Docket No. 50-336
B11827

Millstone Nuclear Power Station, Unit No. 2
Reply to Request for Additional Information on Spent Fuel Storage Capacity

Millstone Nuclear Power Station, Unit No. 2
Response to Request for Additional Information on
Spent Fuel Storage Capacity

FIGURE 1

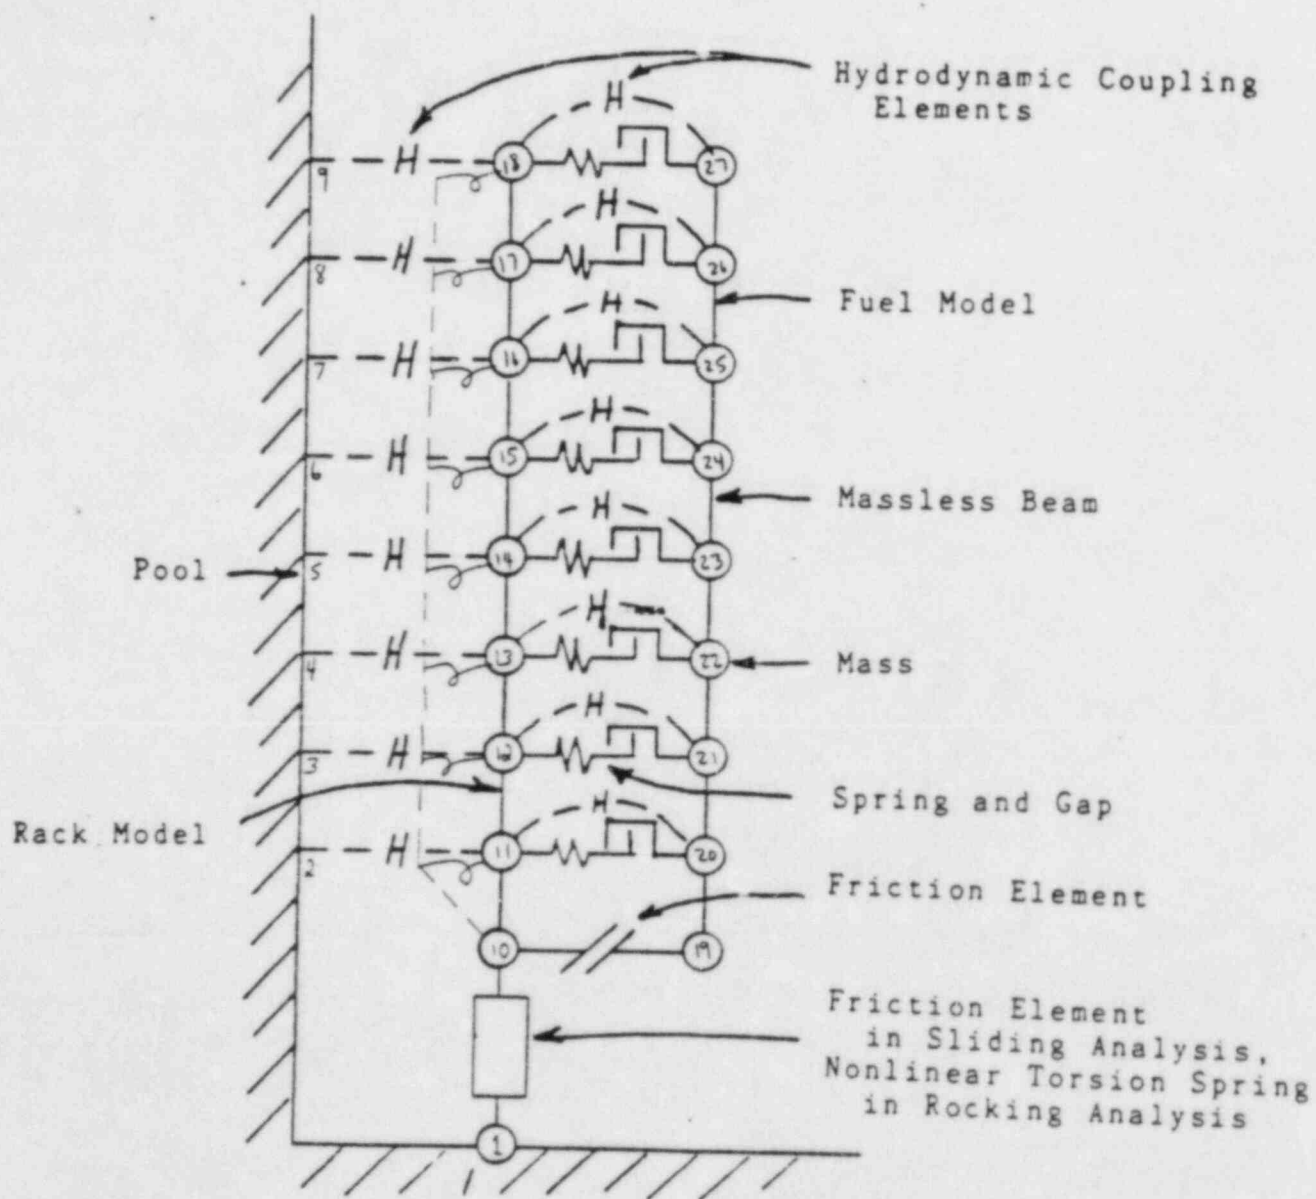
3. Provide a full description of the mathematical model used for the non-linear rack module analysis.

A schematic description of the mathematical model used for the non-linear rack module analysis is shown in Figure 1. The model is two-dimensional, with each mass having a translational and a rotational degree-of-freedom. Mass nodes 1 through 18 were used to represent the fuel rack module. These mass nodes were linked by massless flexible elements. Similarly, mass nodes 19 through 27 were used to represent the fuel. Hydrodynamic couplings, designated by element H, are included between the rack module nodes and the pool structure nodes, and between the fuel nodes and the rack module nodes. Nonlinear gap-spring elements were used to represent the possibility of impacting between the fuel and the rack module. The fuel was coupled to the base of the rack module by a "slip-stick" friction element. An element at the interface of the module base and the pool liner represented a "slip-stick" friction element in the sliding analysis and a nonlinear torsion spring in the shear and rocking analyses.

CESHOCK Model of Millstone 2 Region II
7 X 9 Spent Fuel Rack Module

FIGURE 1
ISOMETRIC VIEWS AND KEY DIAGRAMS

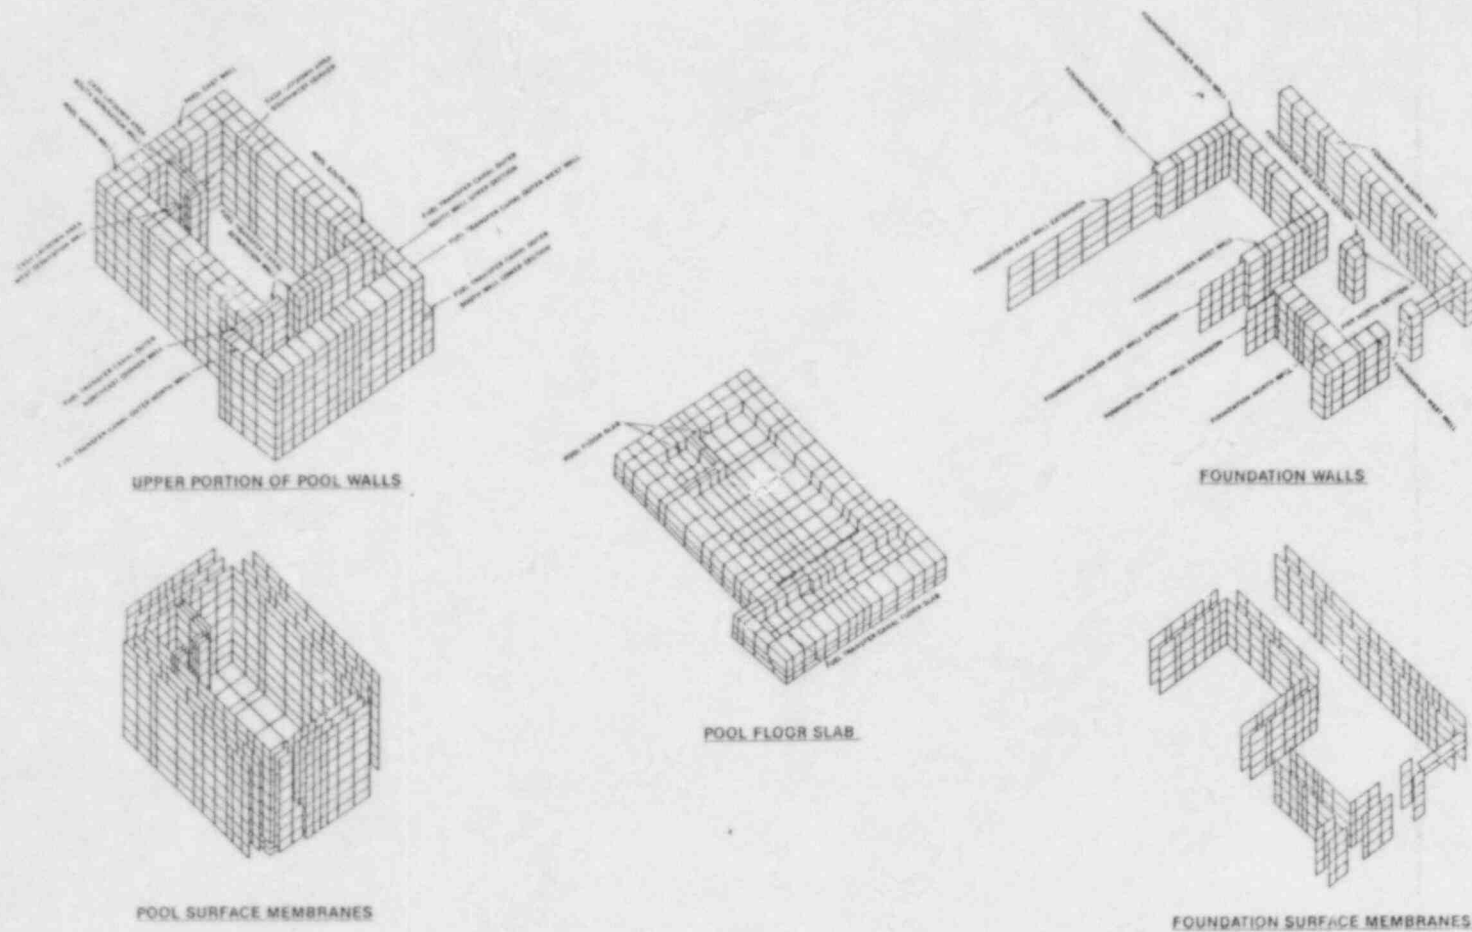
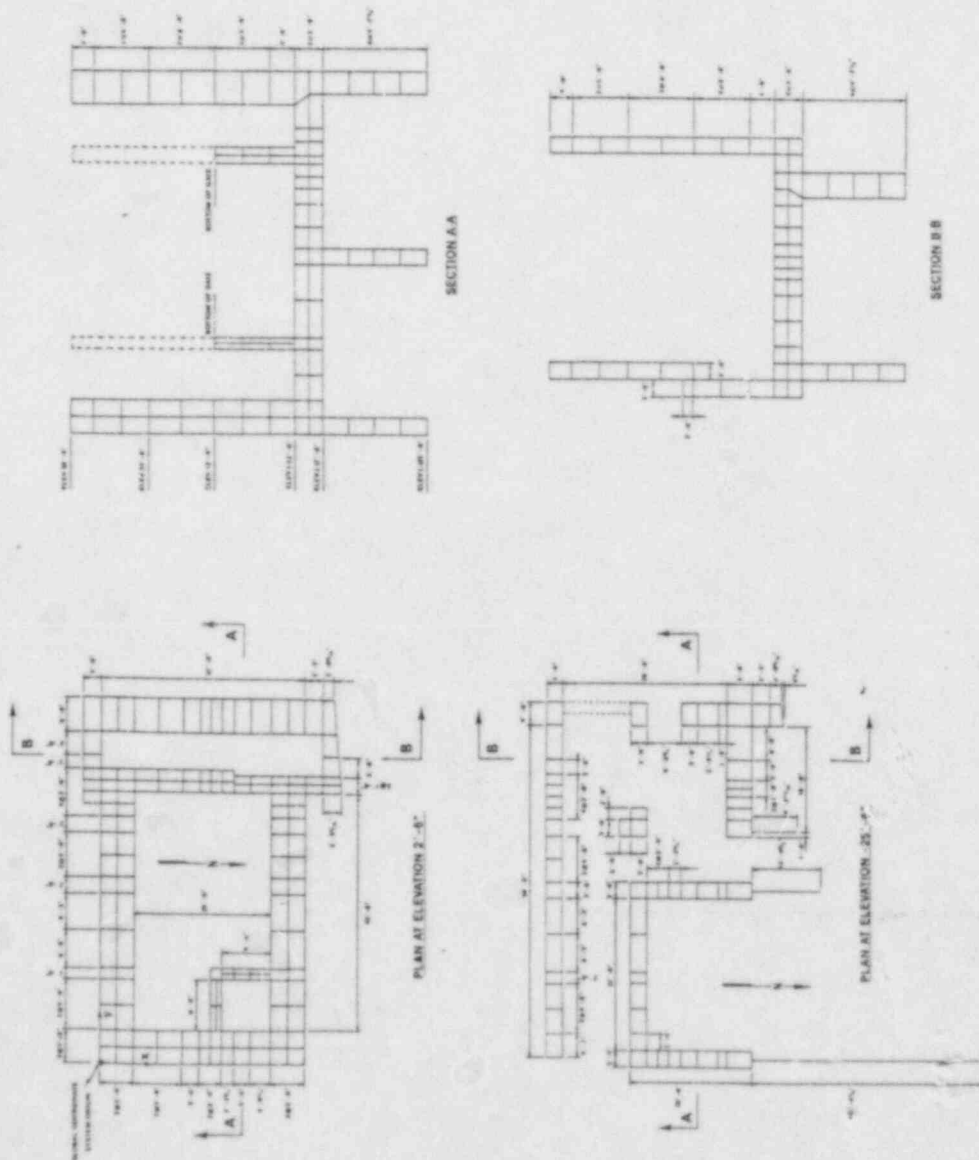
11.a. Provide sketches and drawings of the portions of the pool and auxiliary building structures to be modeled.

This section provides the finite element plots of the spent fuel pool, pool liner, and associated auxiliary building components covered by the analyses.

The models were derived based upon information supplied on the following NUSCO-Millstone Unit No. 2 drawings: 25203-11090 through 11099, 11104, 11106, 11107, 11112, 11126, 11127, 27016, 27018, 27019, 270122, 51044, 51045.

The spent fuel pool and associated auxiliary building components model contain over 9,600 degrees of freedom. Sketches are also provided of the floor liner plate model used in the analyses.
